PLANNING COMMISSION REPORT
Regular Agenda – Public Hearing Item

PC Staff Report
11/17/14

**ITEM NO. 2 SPECIAL USE PERMIT FOR VERIZON WIRELESS; 1725 BULLENE AVE
(SLD)**

SUP-14-00312: Consider a Special Use Permit for a new 120' Verizon Wireless communications tower located at 1725 Bullene Ave. Submitted by PAMCORP LLC for Verizon Wireless LLC on behalf of Steven L. Eudaly, property owner of record.

Figure 1: Residential Use Locations

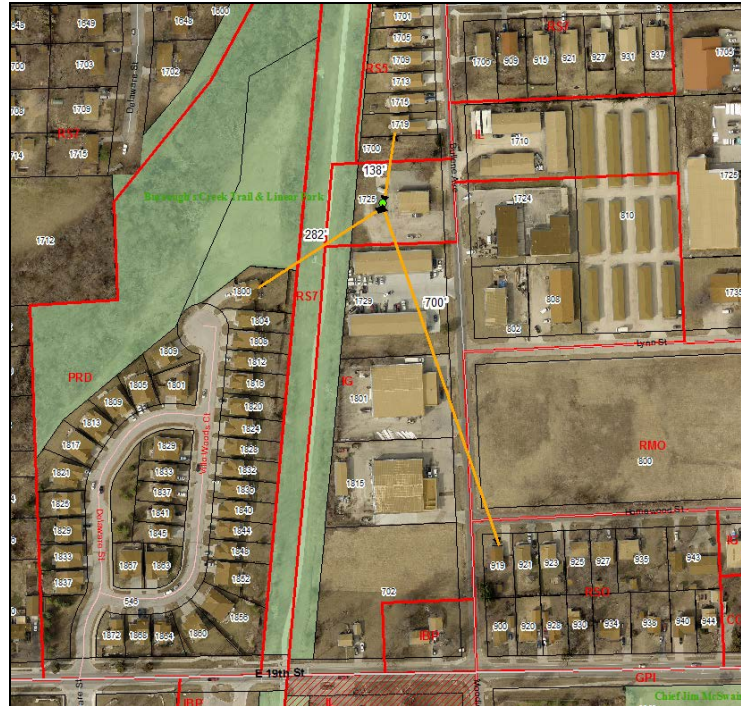
The proposed site location is the Burroughs Creek Corridor, an existing industrial area. An existing park is located immediately west of the subject property. The following graphic shows the location of the nearest existing residential uses in the immediate area.

SP-1

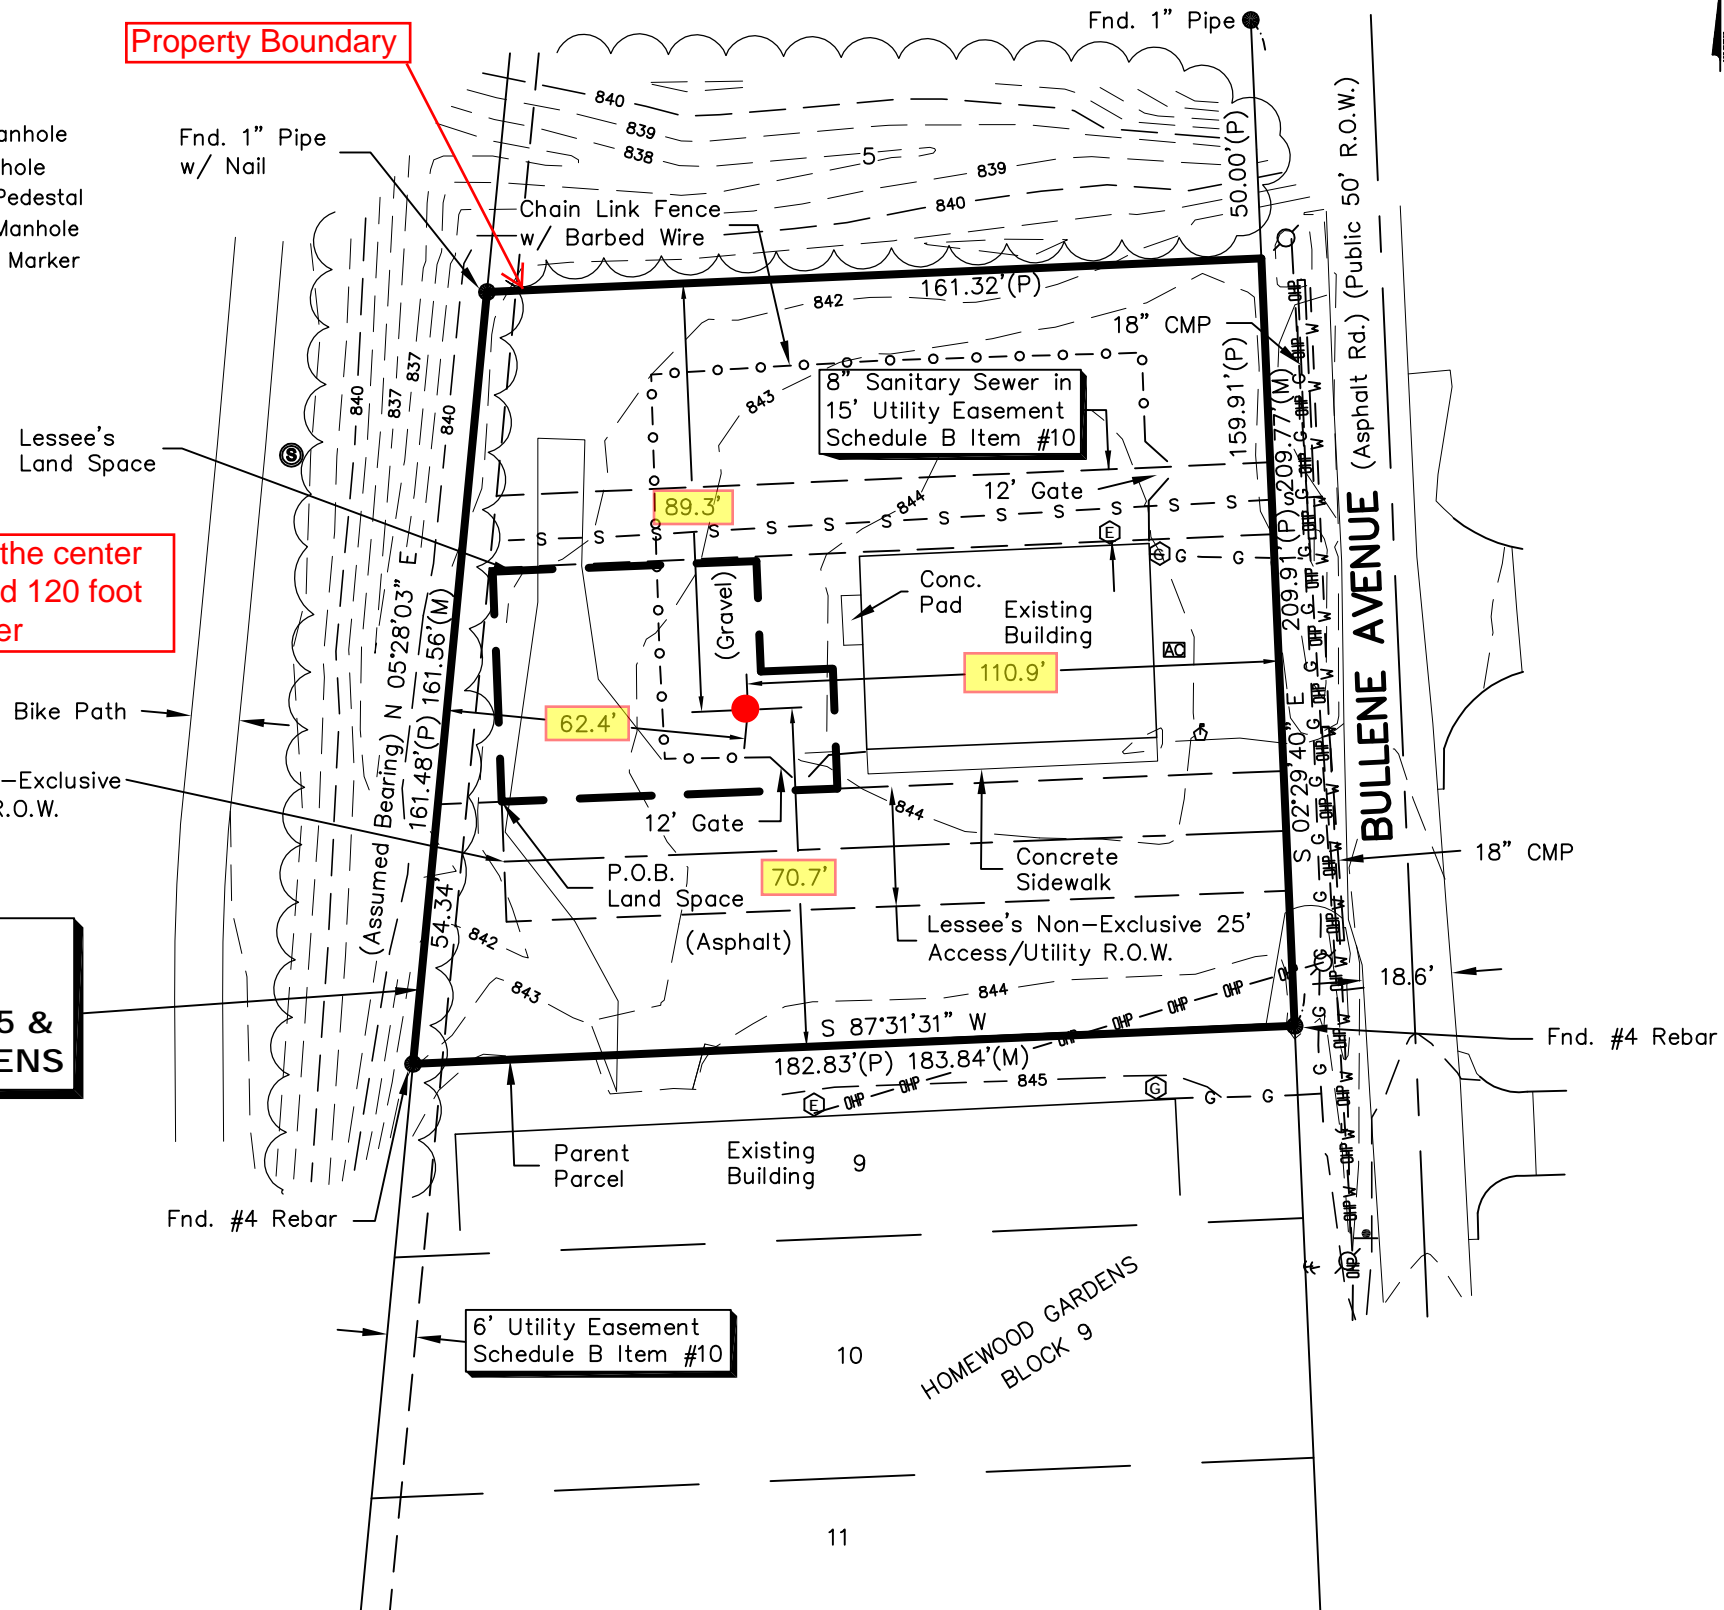
Tower height and setback are related. The Development Code requires a tower to be "setback from the property line in all directions a distance equal to at least one-half the height of the telecommunications tower if the site is in or adjoins an R Base District." This setback applies to the north property line and requires a minimum setback of 60'. The proposed tower is located 89.3' from the north property line.

The nearest residential boundary is the north property line. The proposed tower is 89.3' south of the north property line. The property immediately north of the subject property is vacant. The next nearest residence is approximately 135' north of the proposed tower.

1. Prior to release of the site plan for issuance of a building permit, the applicant shall provide the following changes and documentation:
 - a. Submission of documentation to demonstrate the tower fall zone will be maintained within the proposed enclosure area.
 - b. Submission of lighting details to show the fixture type, lamp type and size not to exceed 150 watt incandescent lighting, and cut-off feature to shield and direct light downward.
2. Provision of a revised site plan to include a landscape plan per City Staff approval that shows additional landscape to include evergreen shrubs planted 5' on center along the west half of the north property line to provide screening between the proposed tower and the abutting residential zoning to the north.

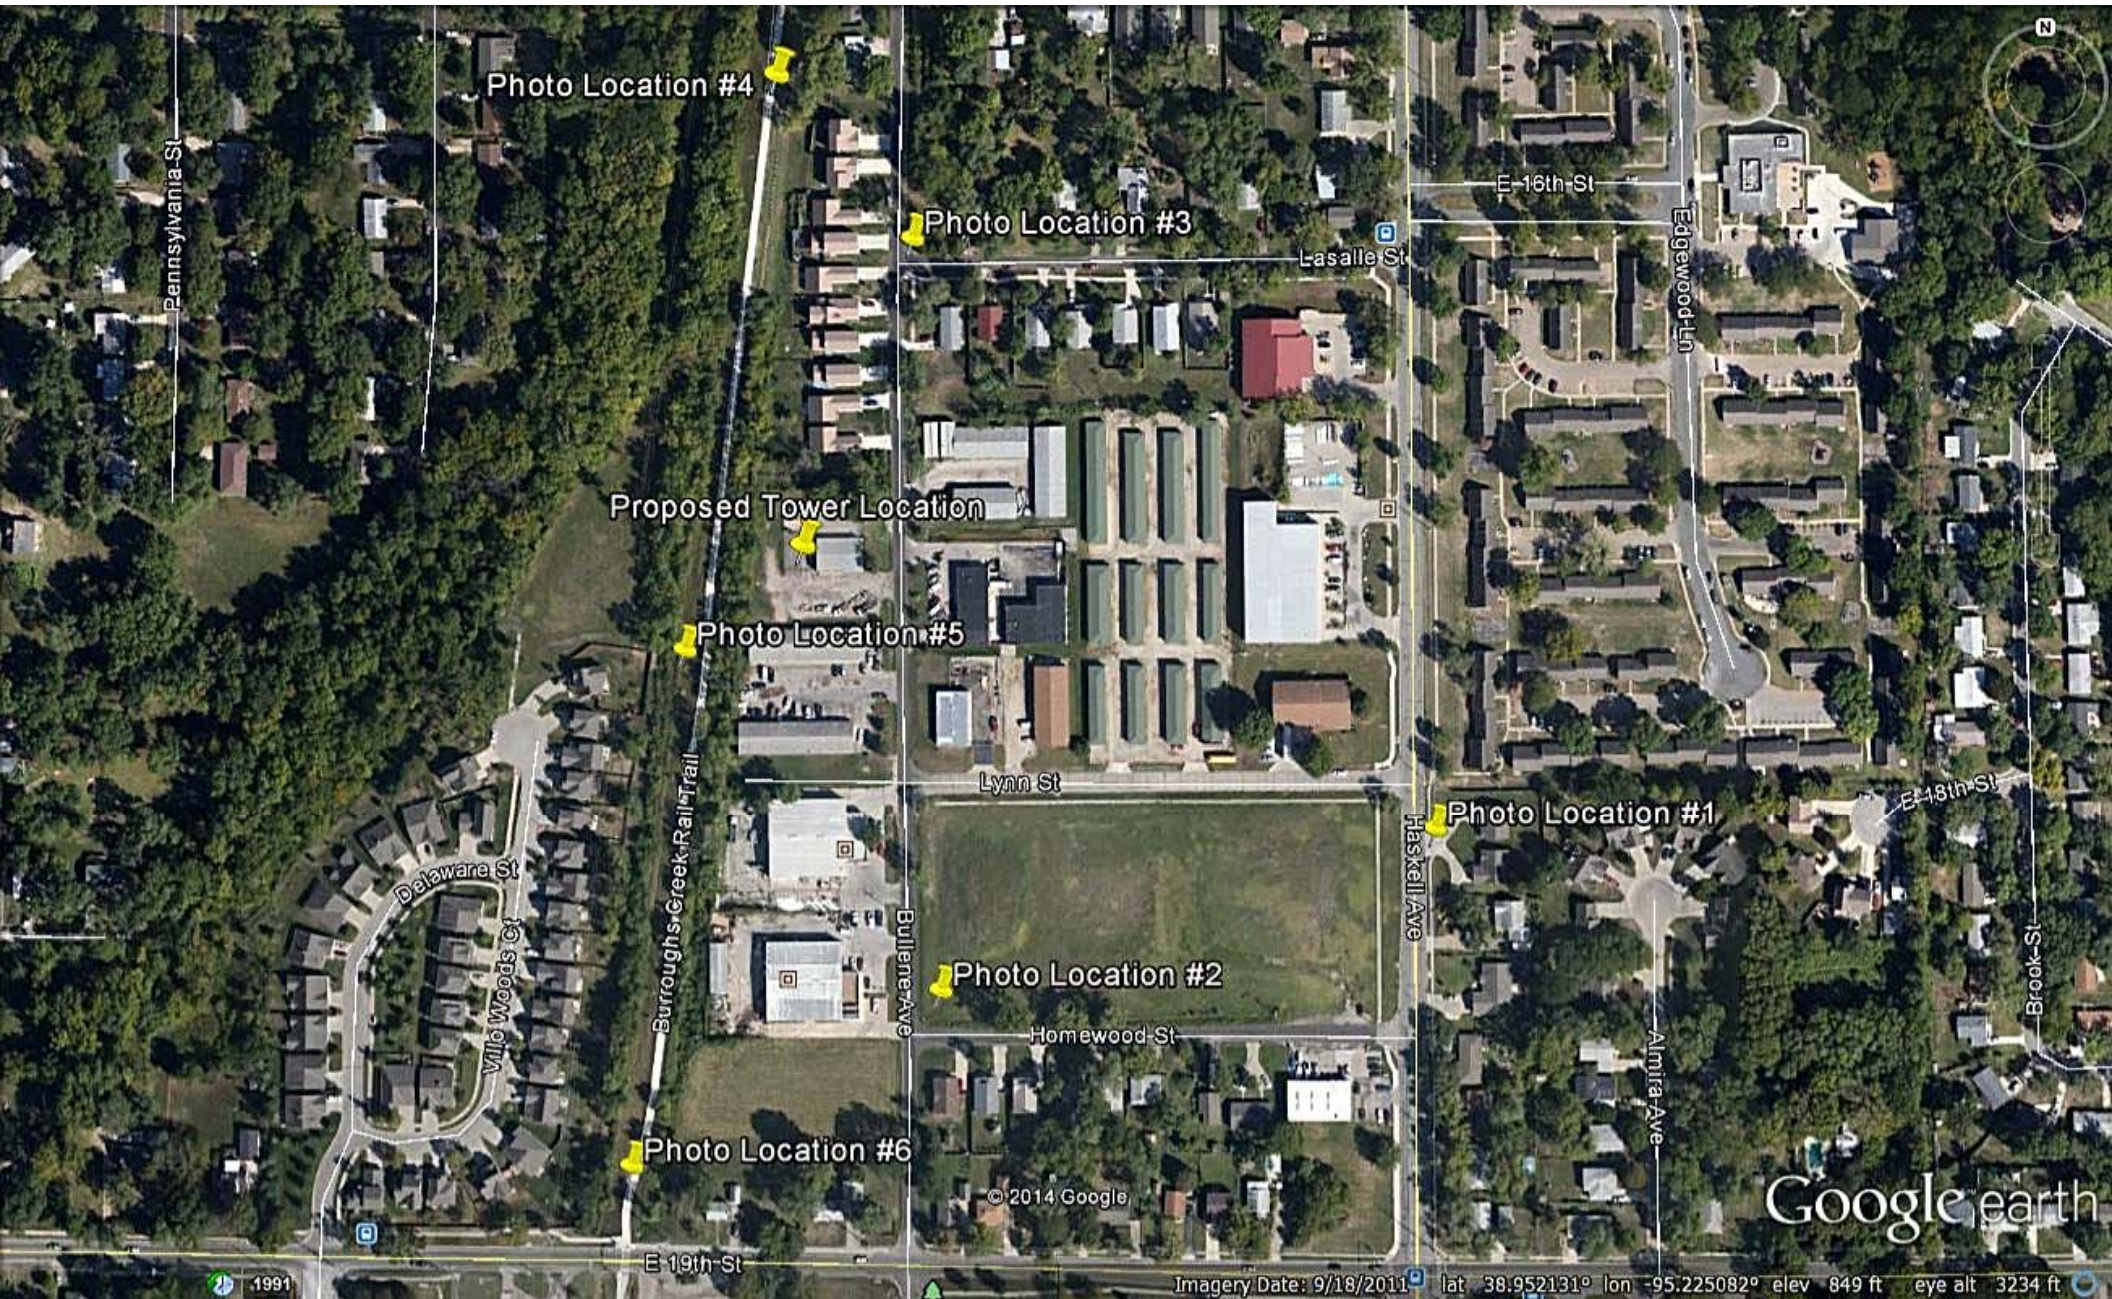
This location is the first place along the path where the proposed tower would be visible. It will remain visible while traveling south for approximately 200 feet. Before and after this 200 foot distance the trees on the east side of the path will provide a buffer between the path and the proposed tower.
